**PLANNED UNIT DEVELOPMENT &
SUBDIVISION STAFF REPORT****Date: March 17, 2016**

<u>NAME</u>	Johnny's RV Park Subdivision
<u>SUBDIVISION NAME</u>	Johnny's RV Park Subdivision
<u>LOCATION</u>	6021, 6049 and 6075 Middle Road and 5684 & 5688 U.S. Highway 90 West (East side of Middle Road, 400'± North of Plantation Road, extending to the East side of U.S. Highway 90 West)
<u>CITY COUNCIL DISTRICT</u>	District 4
<u>PRESENT ZONING</u>	B-3, Community Business District
<u>AREA OF PROPERTY</u>	2 lots / 11.8 ± Acres (Subdivision) 3 lots / 12.9 ± Acres (PUD)
<u>CONTEMPLATED USE</u>	Subdivision approval to create two legal lots of record, and Planned Unit Development Approval to allow multiple buildings on a single building site along with shared access and parking between building sites.
<u>TIME SCHEDULE FOR DEVELOPMENT</u>	None provided

SITE PLAN

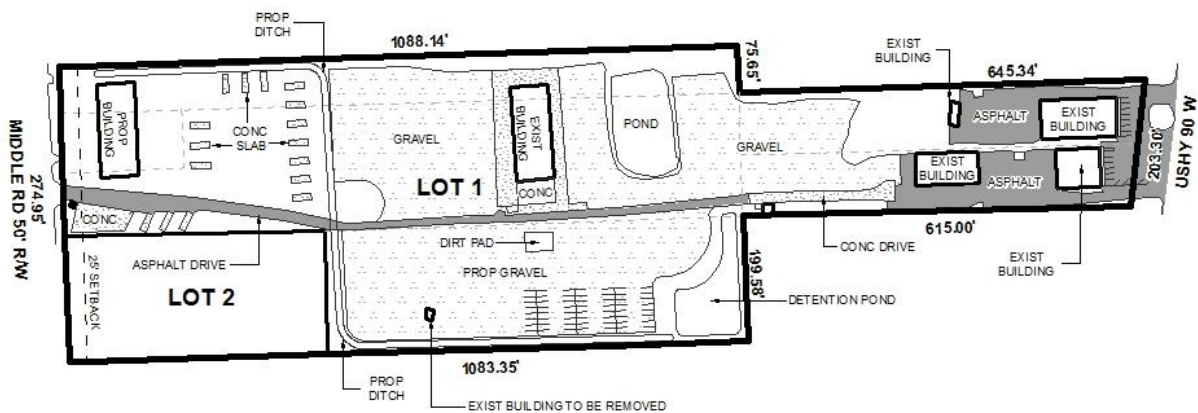
The submitted site plan illustrates the proposed Lot 1 as having shared access and parking with two legal lots of record that front onto U.S. Highway 90 West. There are two existing structures on the proposed Lot 1 that are to be removed from the site, as well as a new 9,000 square foot building to be constructed. The applicant states that there are several warehouses on the site, but does not specify which building are warehouses, how many warehouse employees there are,

The majority of the site is currently surfaced with gravel, and the applicant wishes to expand the gravel surfacing into a currently undeveloped area on the South of the site. A variance application has been submitted to allow the use of gravel surfacing on the site, and will be heard at the Board of Zoning Adjustment's April 4, 2016 meeting. It should be noted, however, that the extent of aggregate surfacing shown on the Planned Unit Development site plan differs from the area depicted on the site plan submitted with the variance application.

The proposed gravel area on the South of the site has 56 parking spaces illustrated, however, because gravel surfacing does not allow for striping to identify parking spaces, bumper stops should be provided, if the area will indeed be allowed to be surfaced with gravel.

No information is provided on the site plan regarding tree planting and landscape area. Because of the proposed redevelopment of Lot 1, the lot should be required to fully comply with landscaping and tree planting requirements, with the exception of perimeter trees along the interior property line shared with the Planned Unit Development. The lots fronting U.S. Highway 90 West should be required to fully comply with landscaping and tree planting requirements at such a time as they are redeveloped by 50% or more.

The proposed site plan does not indicate a dumpster on the site. If approved, the site plan should be revised to indicate either a dumpster connected to sanitary sewer and an enclosure in compliance with Section 64-4.D.9. of the Zoning Ordinance, or placement of a note stating that curb-side pickup will be utilized.

- 1) revision of the site plan to indicate the use of each building as well as the number of warehouse employees;
- 2) revision of the site plan to illustrate full compliance with tree plantings and landscaped area with the exception of perimeter trees along the interior property line shared with the Planned Unit Development for the proposed Lot 1;

- 3) illustration of bumper stops for the proposed gravel parking spaces on the South of the site or explain need;
- 4) indicate either a dumpster connected to sanitary sewer and an enclosure in compliance with Section 64-4.D.9. of the Zoning Ordinance, or placement of a note stating that curb-side pickup will be utilized;

- 9) depiction of aggregate areas to coincide with the Board of Zoning Adjustment site plan.
